Section 4.55(1A) Modification Application

Amendment to SSD-66826207

405 Pacific Highway, 5 Falcon Street and 8 Alexander Street, Crows Nest

30 April 2026

Figure 2 Extract of the Proposed Height Plane Diagram (Source: Turner)

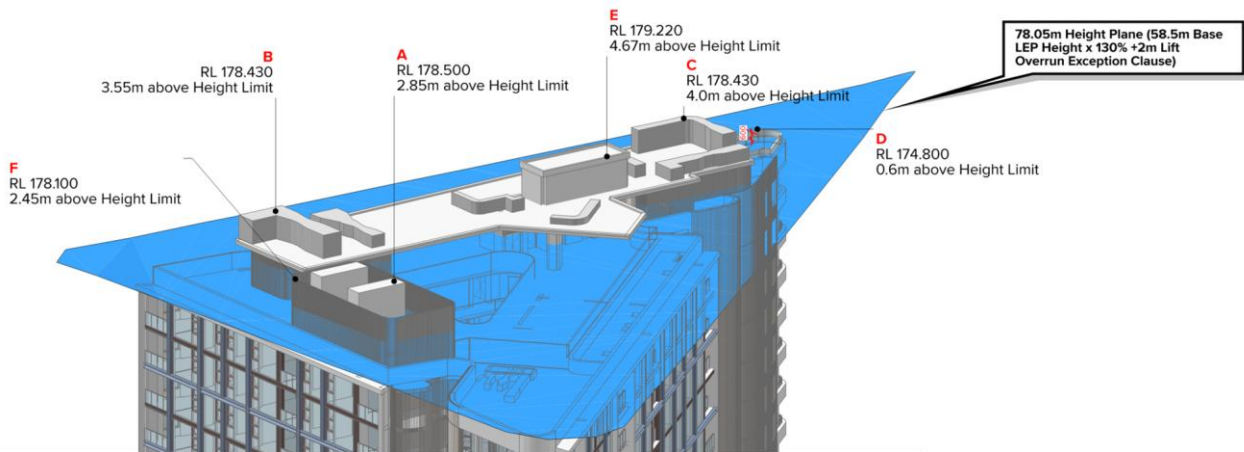
The approved lift overrun height of RL 177.90 is proposed to increase to RL 179.22, representing an increase of 1.32m. This corresponds to an increase in the overall maximum building height from 81.40m to 82.72m, also an increase of 1.32m, or approximately 1.62% above the approved height (**Figure 2**).

Adjustments are also proposed to the plant room and plant screen; however, these elements remain below the lift overrun and do not represent the highest point of the building.

The additional height is confined to rooftop plant and lift overrun structures and does not introduce any additional habitable floor space or changes to the approved building envelope.

Figure 4 Additional Shadows at 10AM (Source: Turner)

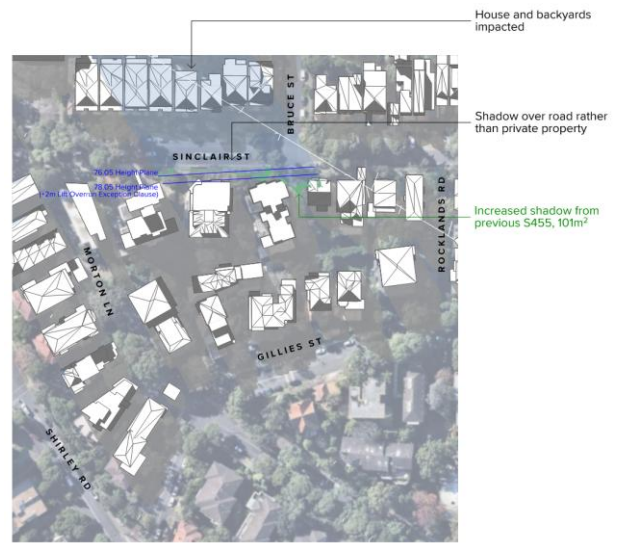
Updated solar and shadow analysis has been undertaken to assess the impact of the proposed minor increase in building height associated with rooftop plant and lift overrun.

A small portion of additional shadow extends onto isolated residential properties during the morning period, however, these impacts are minor, transient and do not materially affect the solar access of those dwellings. By midday and into the afternoon, any additional shadow is negligible and limited to building roofs or non-sensitive surfaces (**Figure 3 - Figure 6**).
